NOVI CONCRETE PLANT JSP22-08

Public hearing at the request of Crown Enterprises, LLC, for Preliminary Site Plan, Wetland Permit, Woodland Permit, and Storm Water Management Plan approval for a new 8,700 square foot concrete plant with two silos. The subject property is approximately 20 acres and is located at 46844 Twelve Mile Road in Section 9, north of Twelve Mile Road and west of West Park Drive. The southern portion of the site is zoned I-1, Light Industrial District and the northern portion is zoned I-2, General Industrial District.

PLANNING REVIEW

Planning Review NOVI CONCRETE PLANT

SHEET NUMBER
A-201

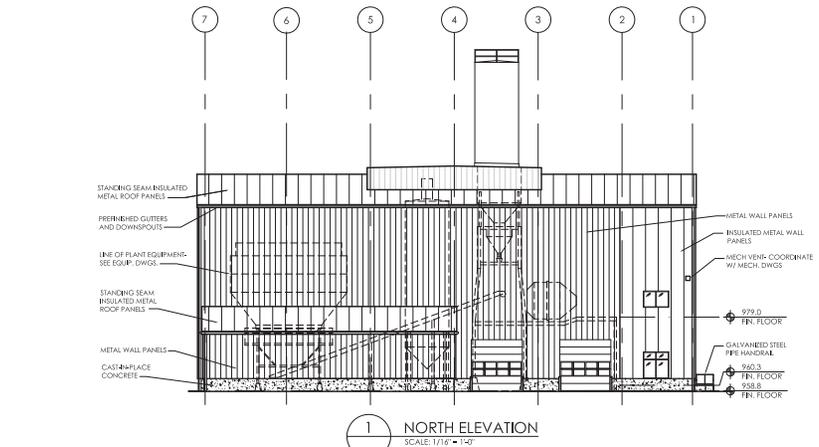
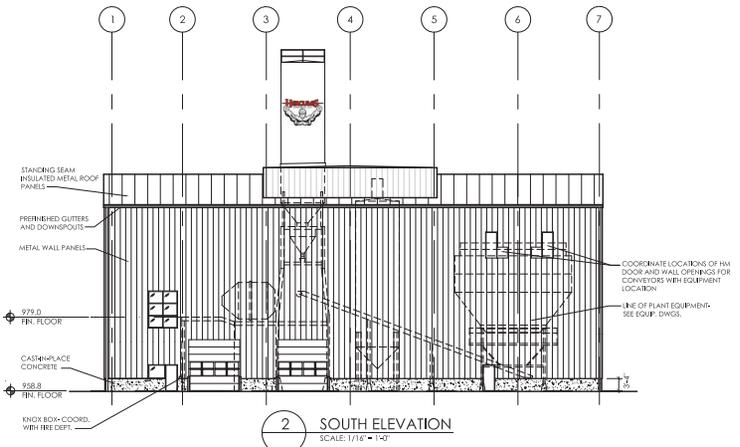
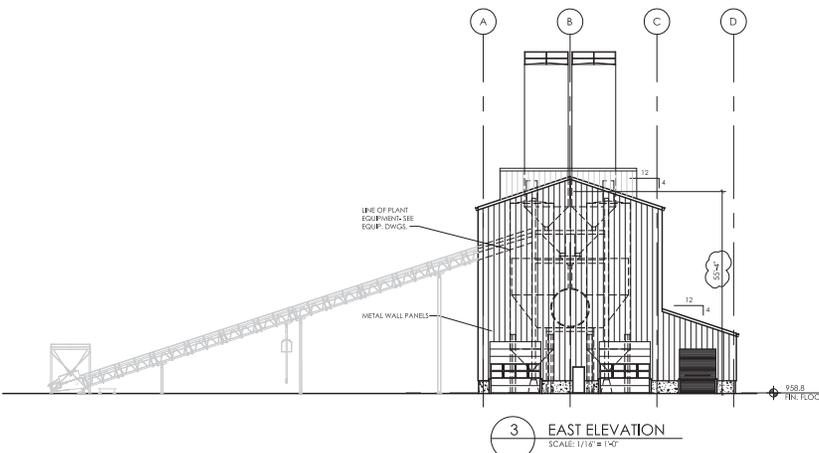
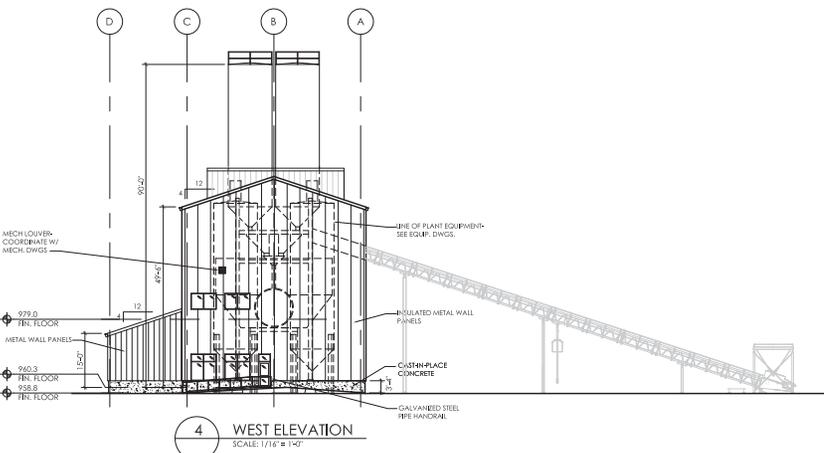
2. Building Height (Sec. 3.1.19.D): The proposed concrete plant has two roofs—one flat roof that has a maximum height of 90 feet and one gable roof that appears to have a height of approximately 50 feet. Currently, the roof measurement for the gable roof is from grade to bottom of the pitch. **The height measurement of the gable roof should be revised to be measured from established grade to the mean height level between the eaves and ridge of the gable roof. Please correct this on Sheet A201.** In addition, the maximum building height in the I-2 Zoning District is 60 feet. While the majority of the structure is 50 feet tall, the 90 foot tall concrete silos exceed the 60 foot height requirement. **The applicant is seeking a variance from the height requirement from the Zoning Board of Appeals.**

of the gable roof. Please correct this on Sheet A201. In addition, the maximum building height in the I-2 Zoning District is 60 feet. While the majority of the structure is 50 feet tall, the 90 foot tall concrete silos exceed the 60 foot height requirement. **The applicant is seeking a variance from the height requirement from the Zoning Board of Appeals.**

Response: The dimension from the proposed floor elevation to the mean height level between the eave and the ridge is provided on the East Elevation on Sheet A-201. A **Variance** for the proposed height has been requested.

Figure 1. Novi Concrete Plant site (boundary outlined in red)
City of Novi Regulated Woodland Map
(Green hatched are regulated woodlands)

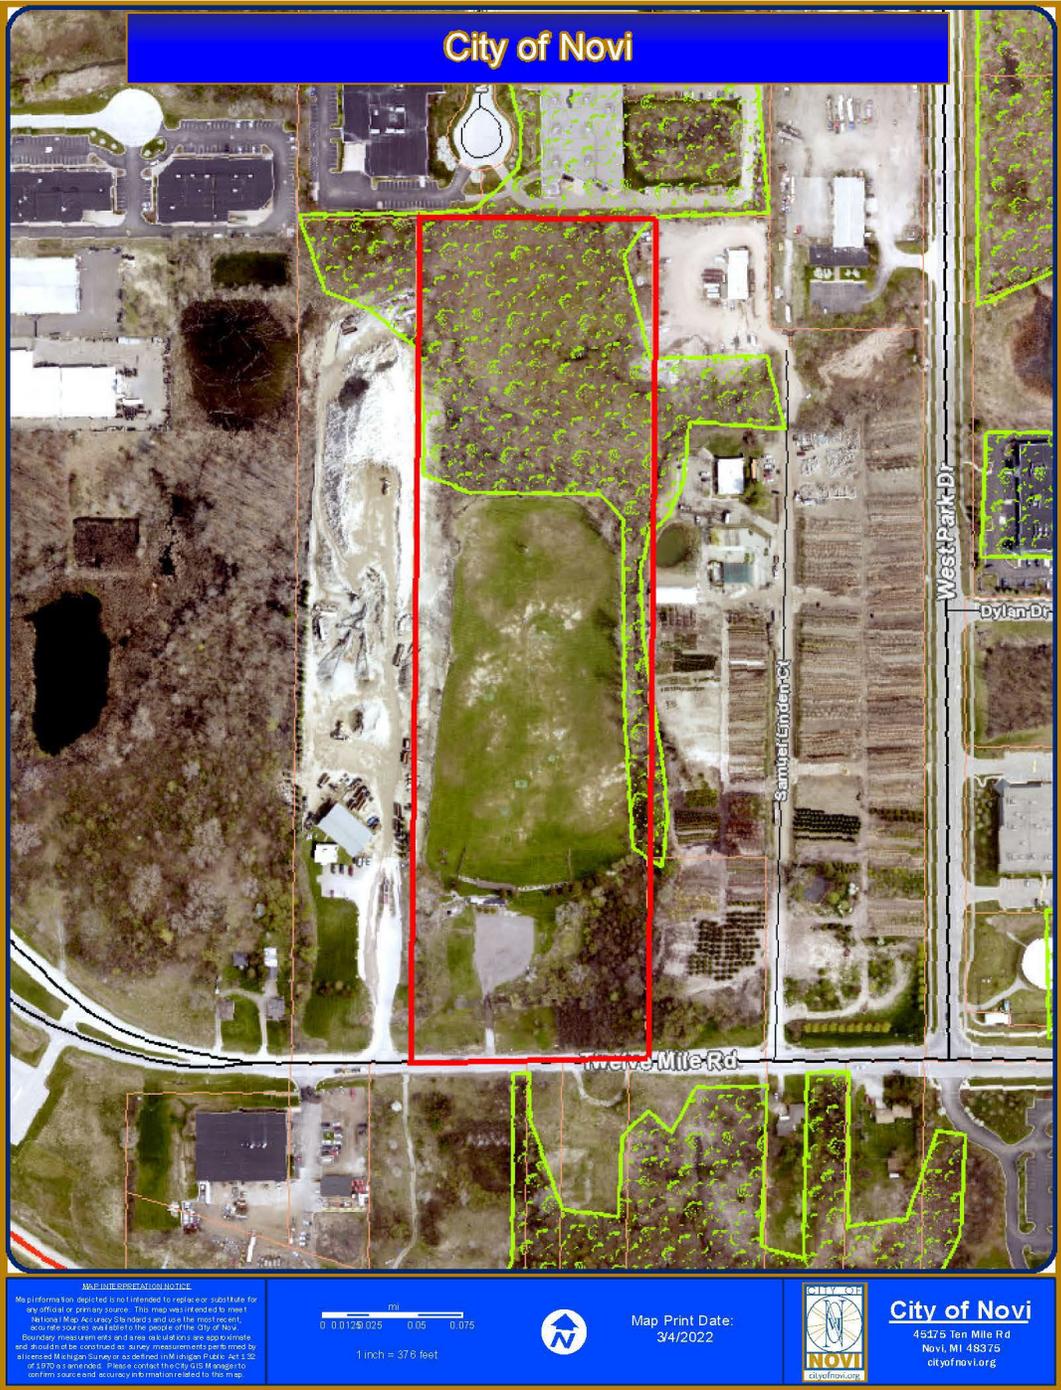
Davey Resource Group, Inc. (DRG) has conducted a review of the revised Preliminary Site Plan Submittal for the proposed **Novi Concrete Plant** located at 46844 Twelve Mile Road (Parcel No.22-09-300-032). The plan set prepared by Angle Design & Engineering (dated: 08/09/2022), proposes construction of a concrete plant on the site. DRG reviewed the preliminary site plan set for conformance with the City of Novi’s Woodland Protection Ordinance, Chapter 37. Based on our review of the pre-application site plan, and the City of Novi Official Regulated Woodlands Map (See Figure 1), **the proposed development contains City-Regulated Woodlands.**
